File Number	PL 21-047	Contact	Kyle Deming, <a href="mailto:kdeming@duluthmn.gov">kdeming@duluthmn.gov</a>	
Type	Special Use Permit – Restaurant	Planning Commission Date		May 11, 2021
Deadline for Action	Application Date	March 26, 2021	60 Days	May 25, 2021
	Date Extension Letter Mailed	April 30, 2021	120 Days	July 24, 2021
Location of Subject		South side of 600 block of W. Central Entrance (Mall Area)		
Applicant	The Parikh Network	Contact	Ed Baksh	
Agent		Contact		
Legal Description		Lot 2, Block 1, Jigsaw Division (010-2589-00020)		
Site Visit Date		April 30, 2021	Sign Notice Date	April 27, 2021
Neighbor Letter Date		April 30, 2021	Number of Letters Sent	18

A 2,287 sq. ft. restaurant with drive-through and 24 parking spaces located in the Jigsaw Division.

PL 21-047  
600 Block of  
W. Central Entrance  
Special Use Permit -  
Restaurant in MU-N

**PHOTOMETRICS PLAN**  
DULUTH, MN 55811

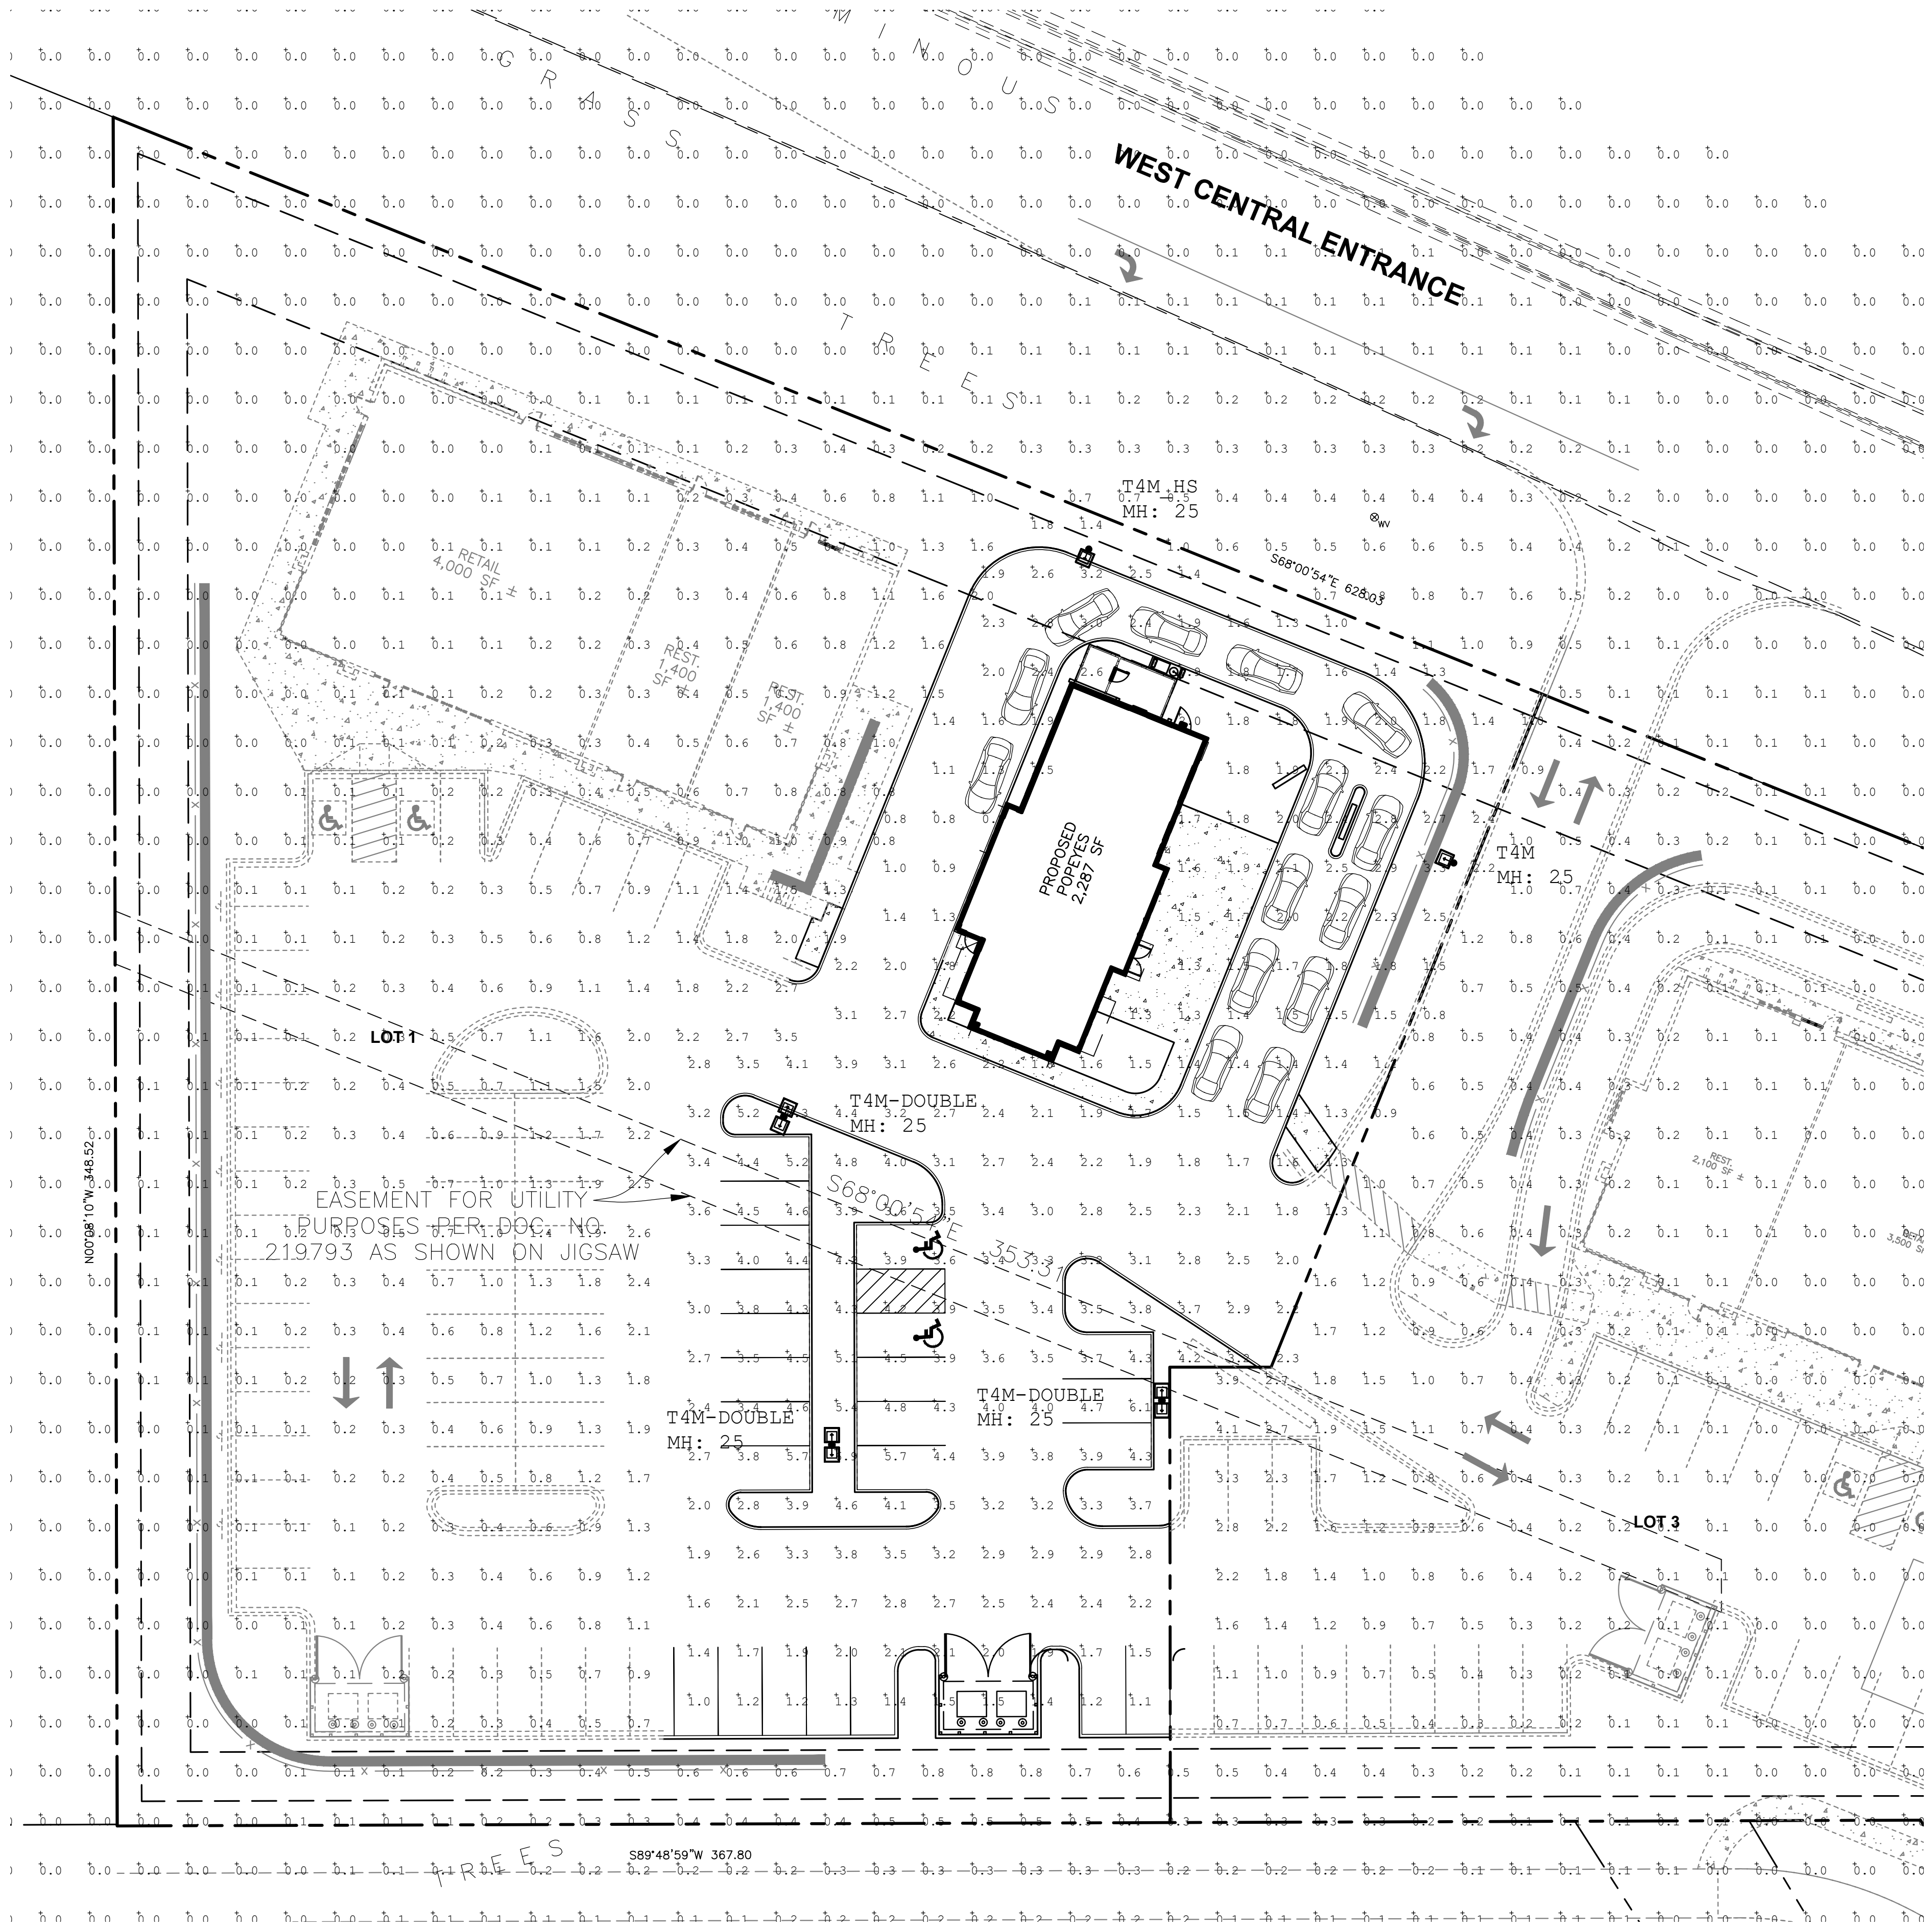
11. Sustainability and building design standards do not apply due to the size of the structure.
12. The submitted photometrics plan shows compliance with Sec. 50-31. However, due to the reconfiguration of the parking lot shown in the Launch Properties site plan, a revised photometric plan will be needed.

- 9) Provide a revised photometric plan that matches the approved site plan.
- 10) Any alterations to the approved plans that do not alter major elements of the plan may be approved by the Land Use Supervisor without further Planning Commission; however, no such administration approval shall constitute a variance from the provisions of Chapter 50.
